TITLE  
TRANSFER PUMP MOUNTING PLATE

SIZE  
C  
DWG. NO.  
11728-200-012  
REV.  
A  
SHT 2 OF 2

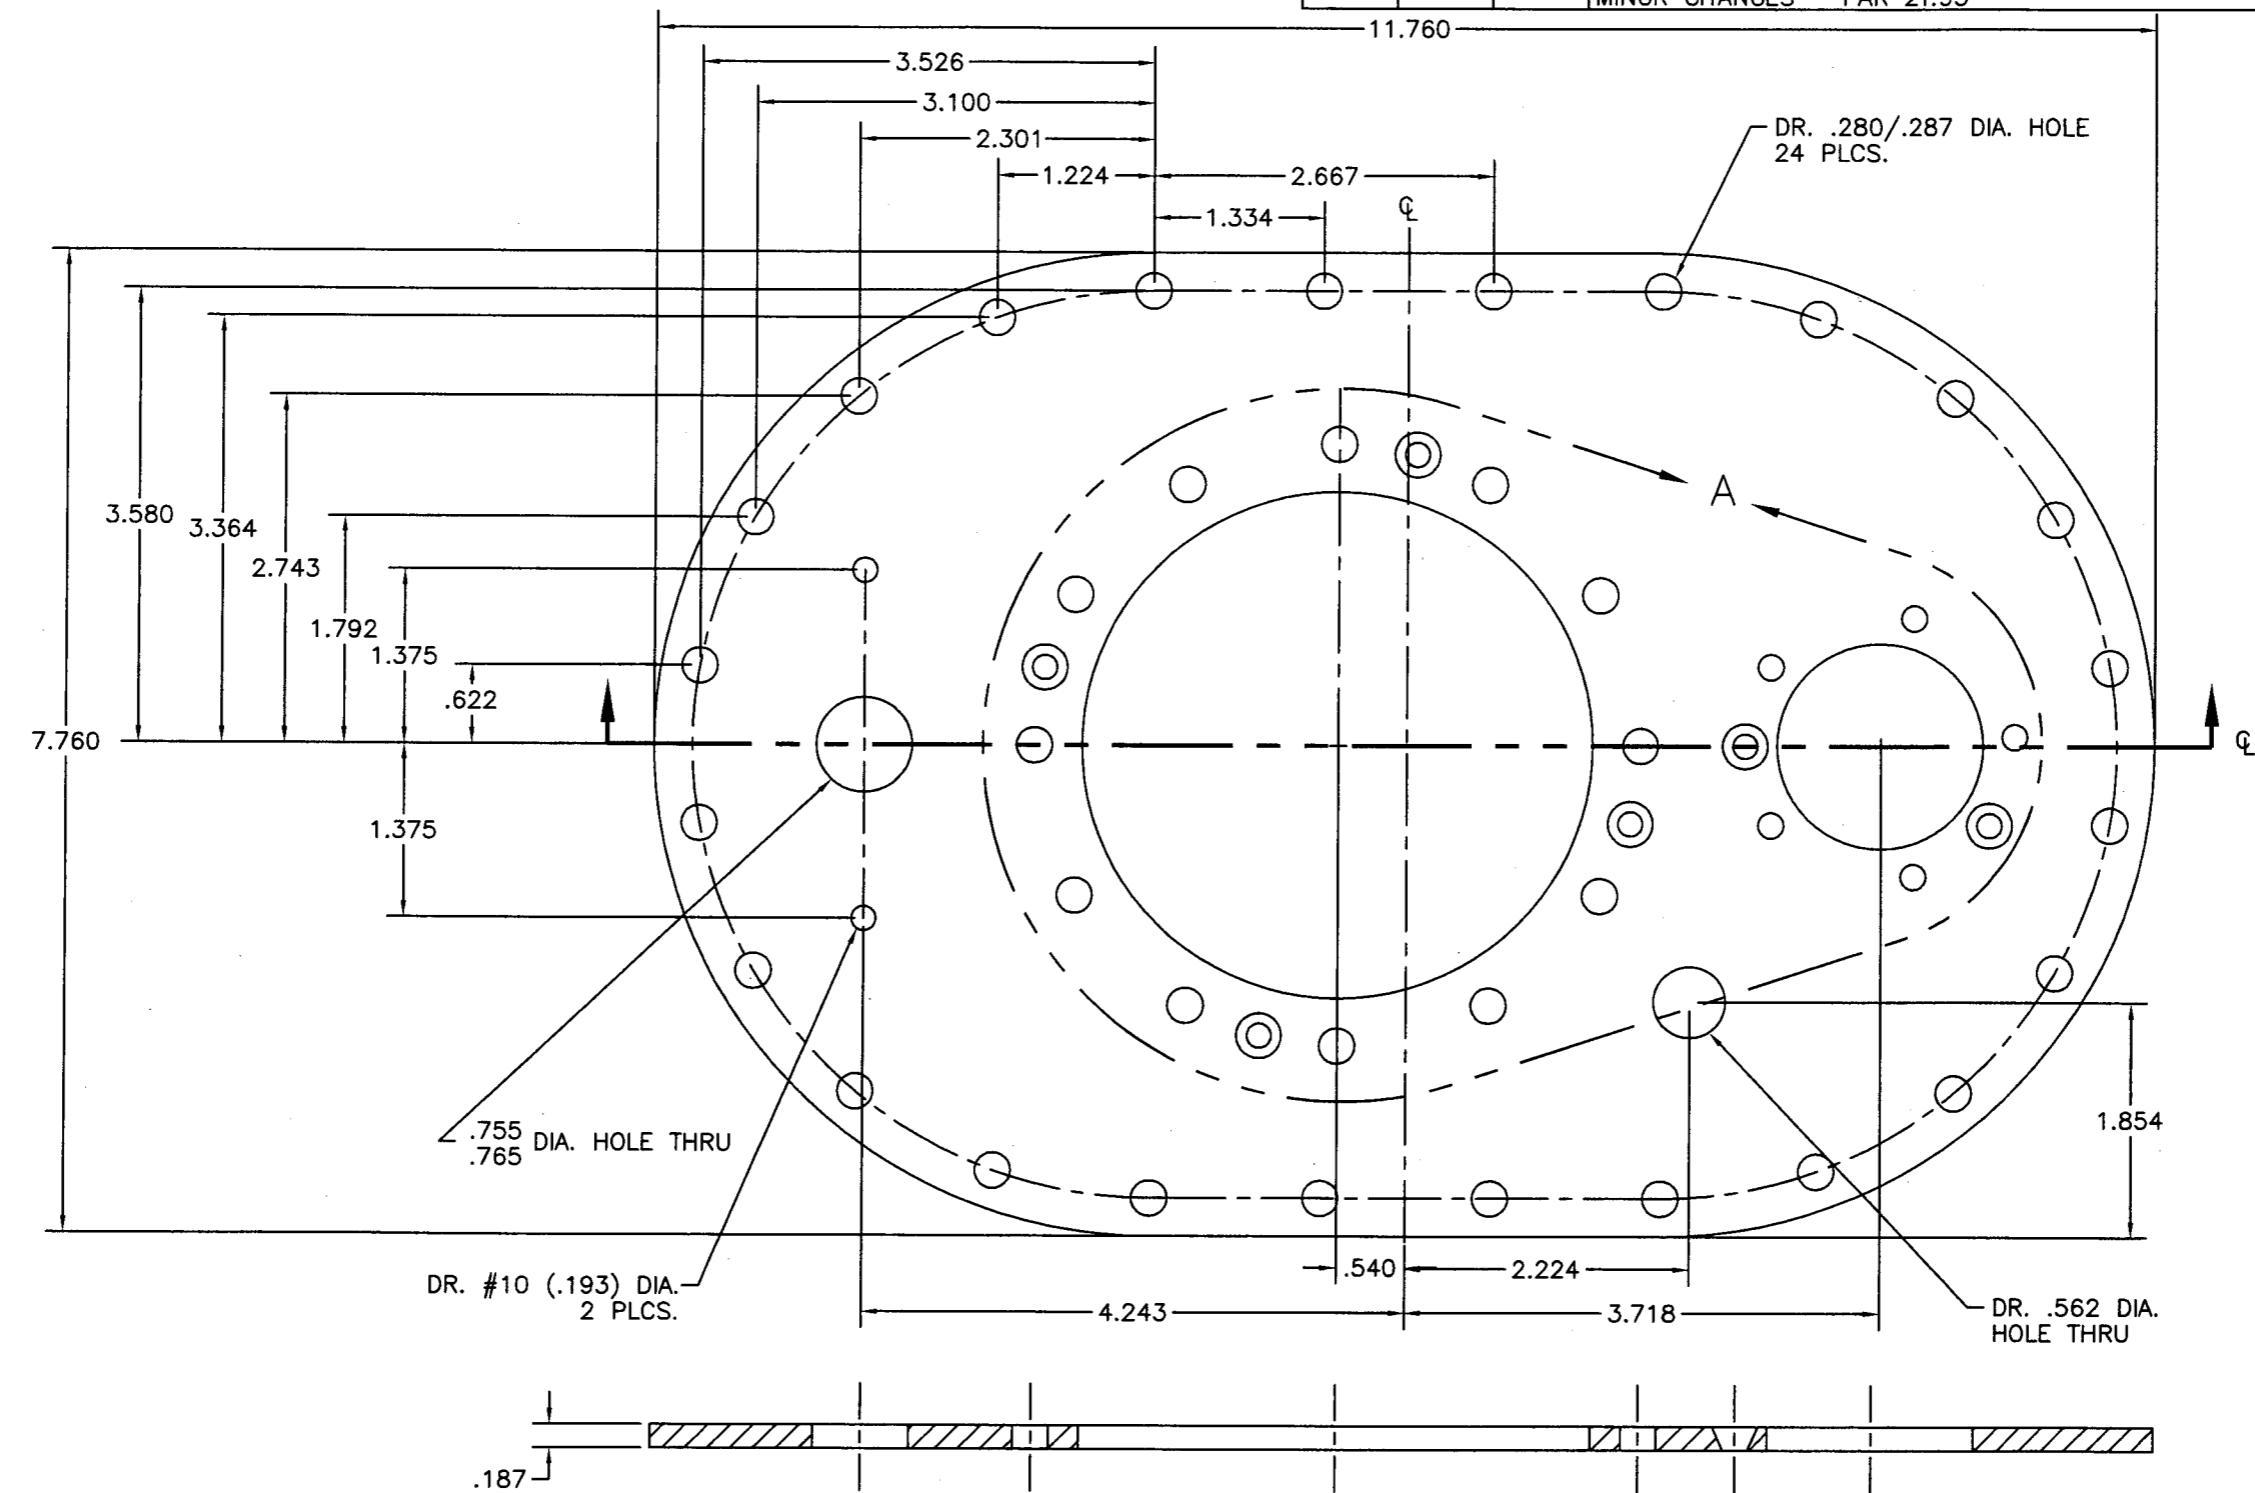
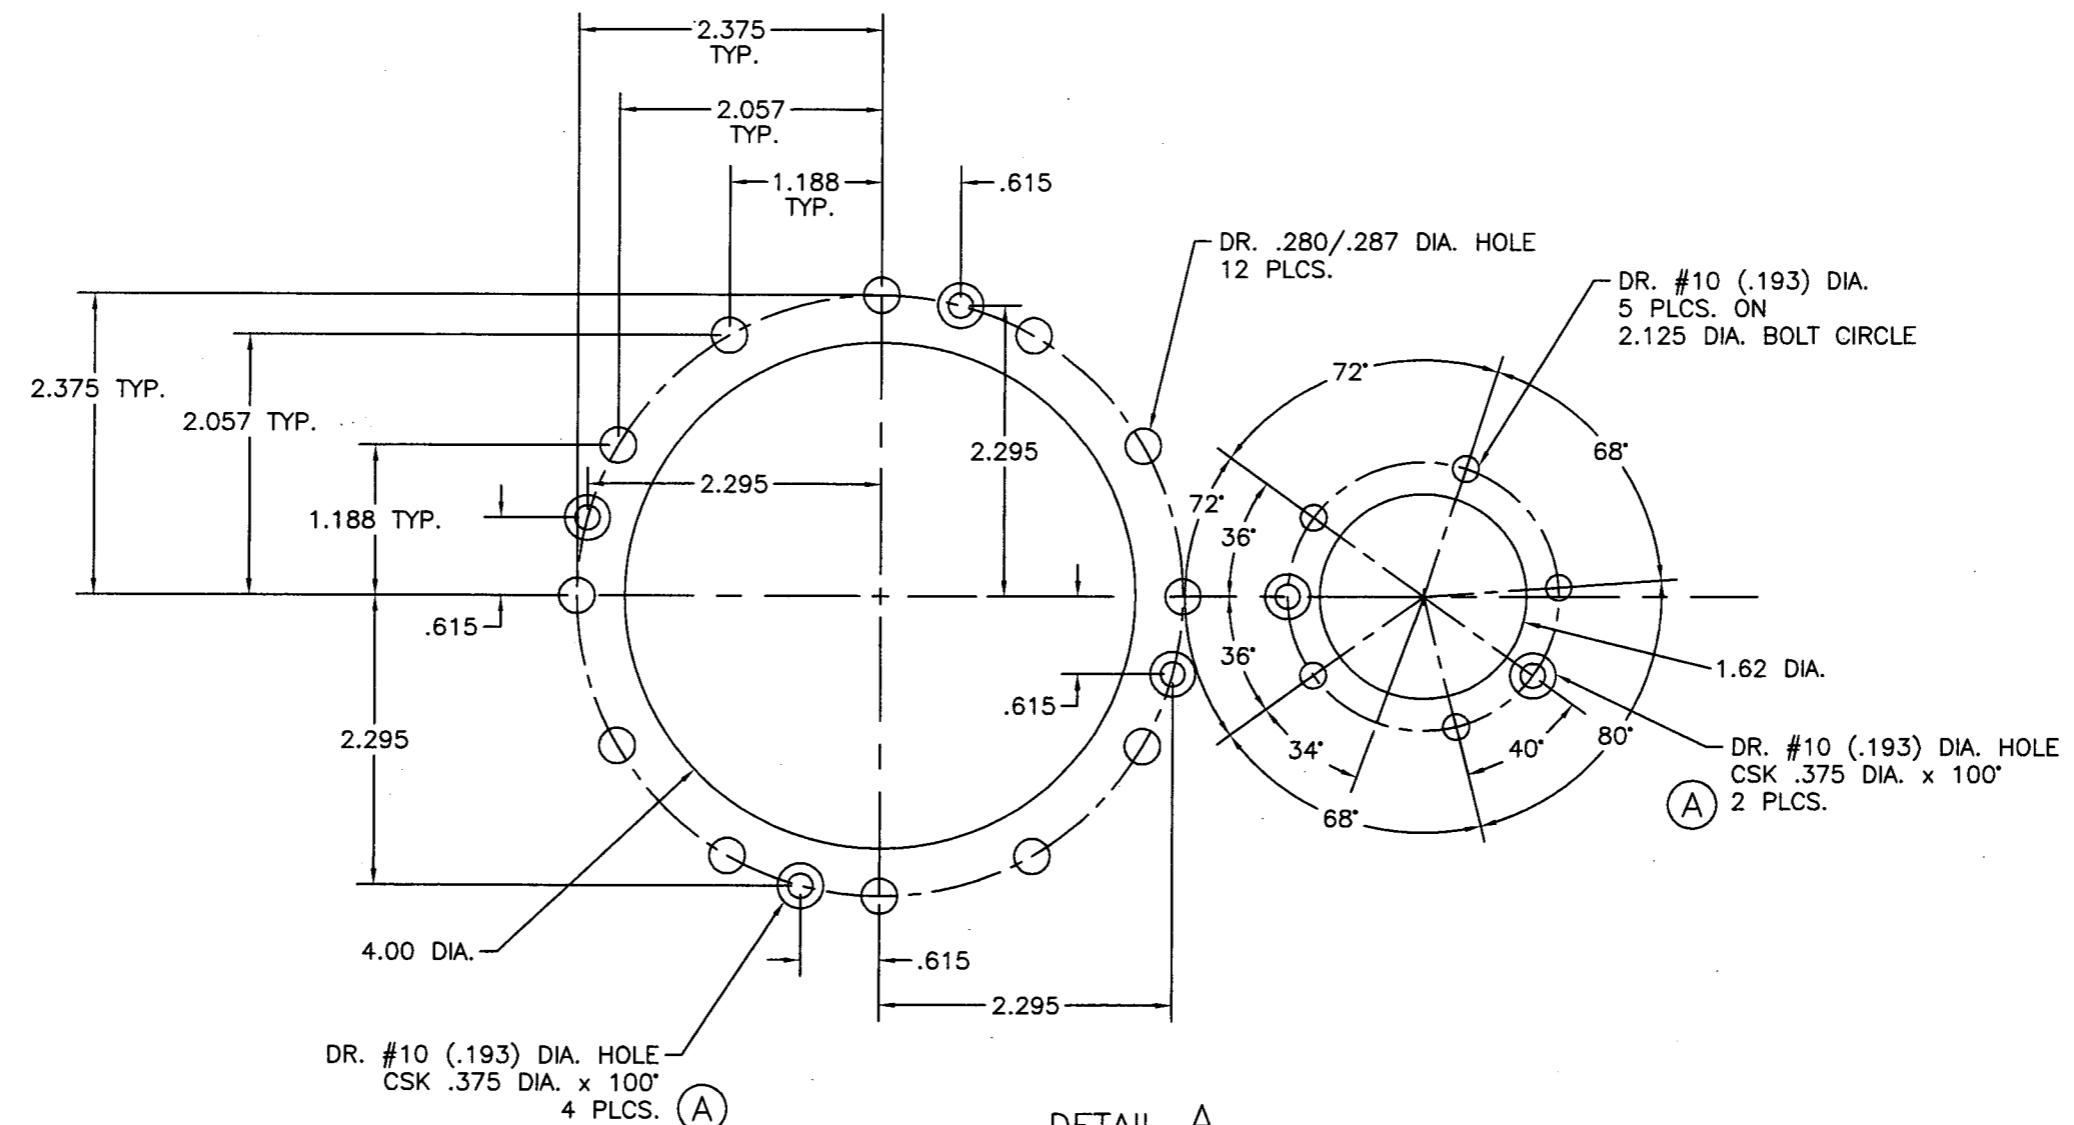
REVISION						
LETTER	DFTSMAN	DATE	DESCRIPTION	APPROVED	DATE	
A	DNN	12/22/99	INCORP. E.O. A-1: ADDED 100° TO ALL CSK HOLES; ADDED NEXT ASSY FOR 412 MODEL INSTALLATIONS. MINOR CHANGES - FAR 21.95	P. SCHWARTZ 00.071	6/16/00
